ITEM 7. DEVELOPMENT APPLICATION: 67-77 EPSOM ROAD AND 95 DALMENY AVENUE ROSEBERY**FILE NO:** D/2014/1977**DEVELOPMENT APPLICATION NO:** D/2014/1977**SUMMARY****Date of Submission:** 19 December 2014

Applicant: Toplace Pty Ltd**Architect:** PTW Architects**Developer:** Toplace Pty Ltd**Owner:** Jolyn Place Pty Ltd**Cost of Works:** \$78,005,461**Proposal Summary:** Stage 2 development application for the construction of four residential flat buildings known as buildings B, C, E and F, as approved within the Stage 1 development consent D/2008/102/B.

Figure 25: Section through Building B which indicates the height non-compliance.

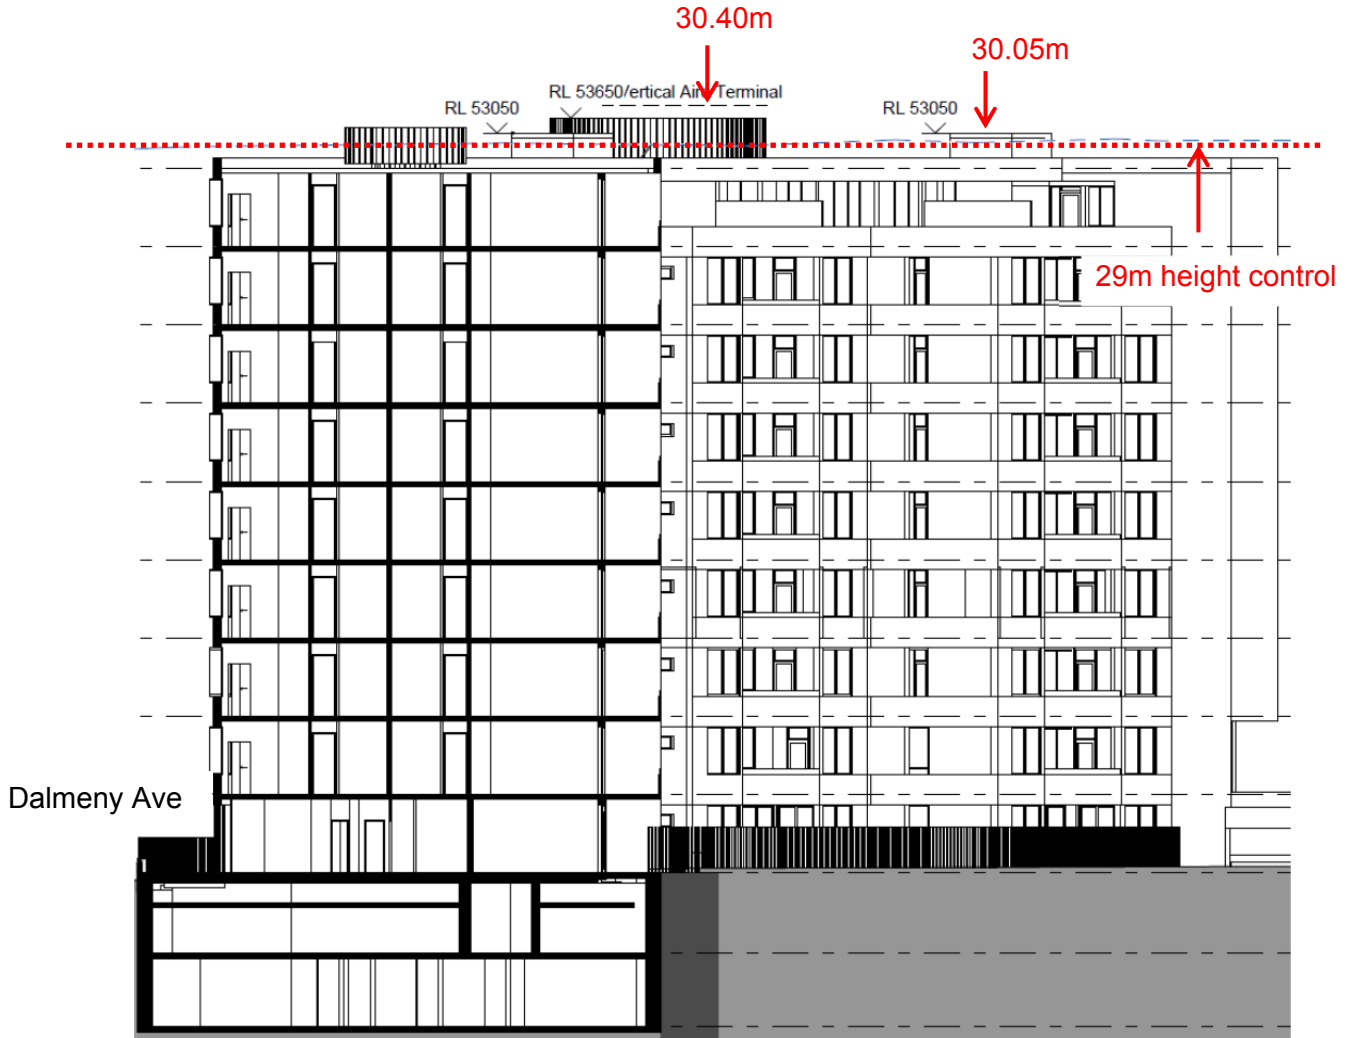
42. The Sydney LEP 2012 height control is 29m and the Sydney DCP 2012 height in storeys control is 8 storeys.

43. The proposal has a maximum height of approximately 30.05m to the top of the lift overrun, and 30.40m to the top of the plant screening. The building parapets and habitable space remain below the 29m control. The proposal is shown in Figure 25.

Figure 26: Approved location of new street (dark boundary) and DCP control (dotted boundary).

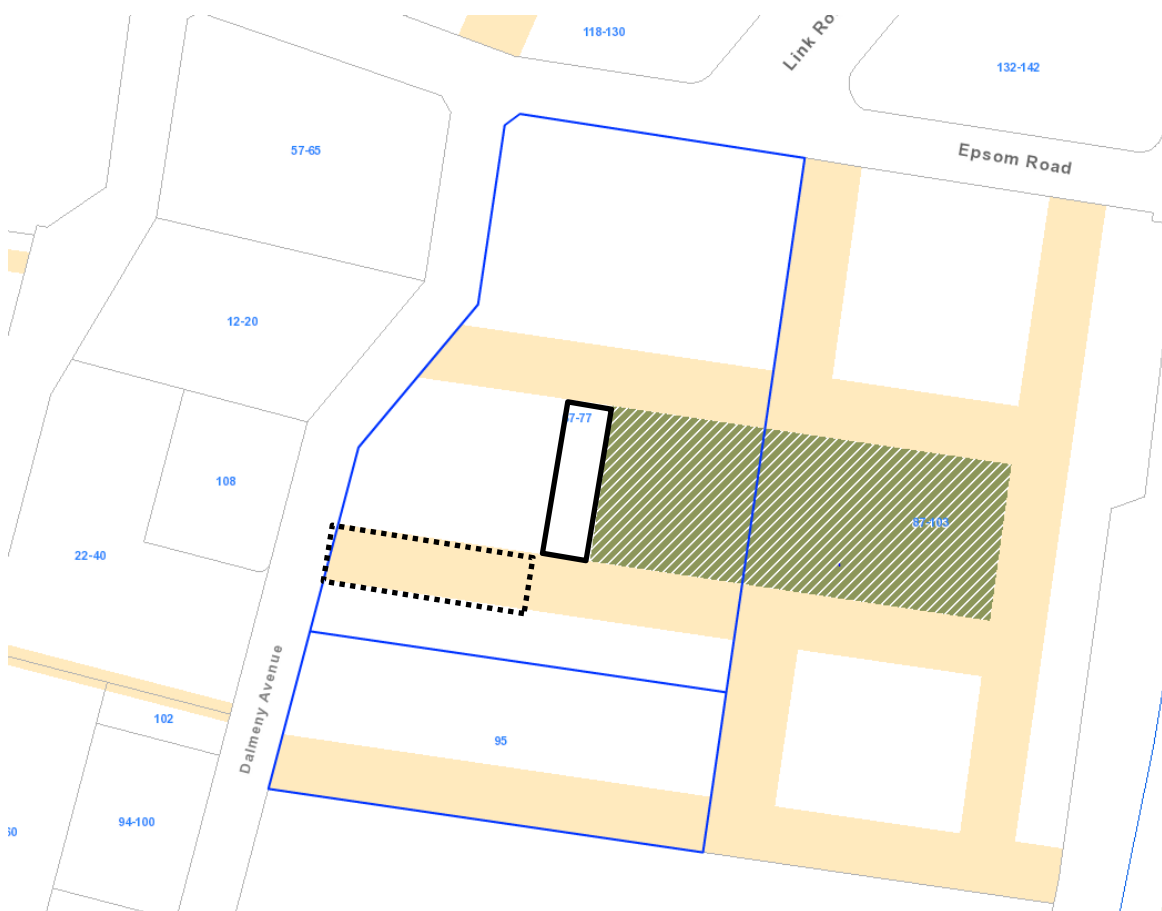
50. It is noted that the location of Banilung Street as approved as part of the Stage 1 DA is inconsistent with street location identified in the Sydney DCP 2012. The approved location runs in a north-south direction adjacent to the park and connects directly to Magari Street. The Sydney DCP 2012 indicates the street in an east-west direction to connect directly to Dalmeny Avenue. The approved Stage 1 location is considered to be acceptable as it provides a street edge to the park and an appropriate street network.
51. Figure 26 below shows the Sydney DCP 2012 and approved Stage 1 location for the street.
